**Urgent Field Safety Notice**  
**Product Correction**  
 Urgent - Immediate Action Required

**Date Issued** September 16, 2019

Abbott has identified a potential reliability issue with the Alinity ci-series Level Sensor, Bulk Solution (LN 04S68-02). The details of the issue and the potential impact is described below.

**Figure 1. Examples of cracked level sensor (Not Acceptable)**

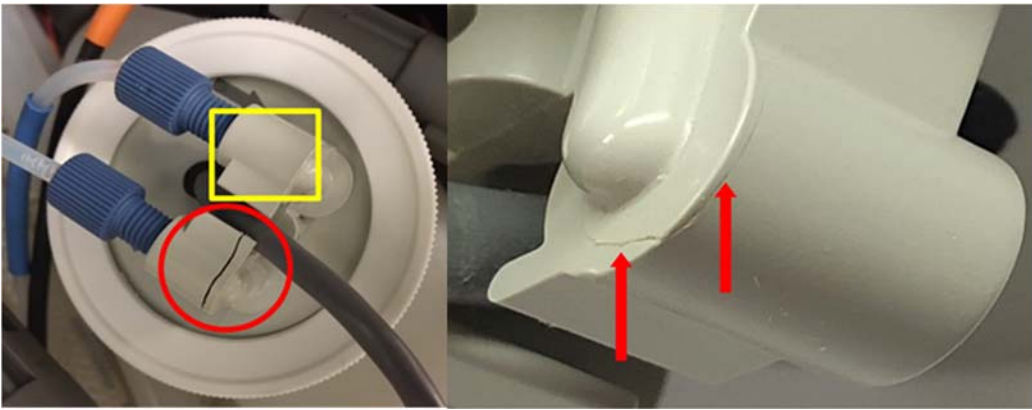
- Crack size and location on inlet and outlet ports is variable. See Figure 1.
  - On each level sensor, there is a “knit” line that is a normal outcome from the manufacturing process. The “knit” line is not a crack or defect in the level sensor. See Figure 2.
4. If crack(s) are detected,
    - Replace the bulk level sensor. LN 04S68-02 may be used until LN 04S68-03 is available. For replacement instructions, refer to the Alinity ci-series Operations Manual, Section 9.
    - Review results generated from the last successful quality control.
  5. When the inspection is complete slide the reservoir bottle tray into the bulk solution reservoir area and close the bulk solution door.

- Area in red circle indicates level sensor crack.
- Area in yellow square indicates undamaged port.
- Area with red arrows indicates cracks.

**Figure 3. Identification of the Level Sensor, Bulk Solution (LNs 04S68-02 and 04S68-03)**

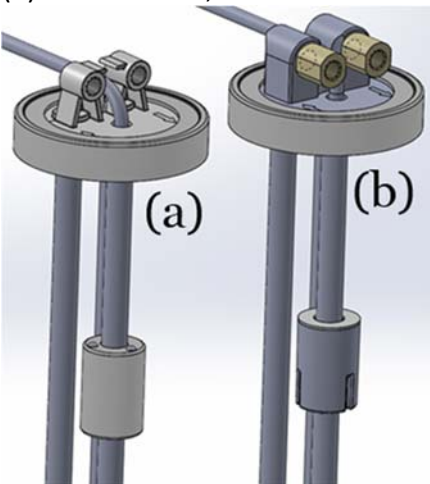
Abbott has redesigned Level Sensor, Bulk Solution (LN 04S68-02) to improve reliability. The redesigned Level Sensor, Bulk Solution (LN 04S68-03) will be available beginning in the fourth quarter of 2019. You may continue to run the system using part number (LN 04S68-02) until the replacement parts (LN 04S68-03) are obtained by taking the recommended actions outlined in this letter. Once the redesigned Level Sensor, Bulk Solution (LN 04S68-03) is available, Abbott recommends the replacement of the LN 04S68-02 in all positions on the Alinity c and i systems.

(a) Level Sensor, Bulk Solution LN 04S68-02, (b) Level Sensor, Bulk Solution LN 04S68-03
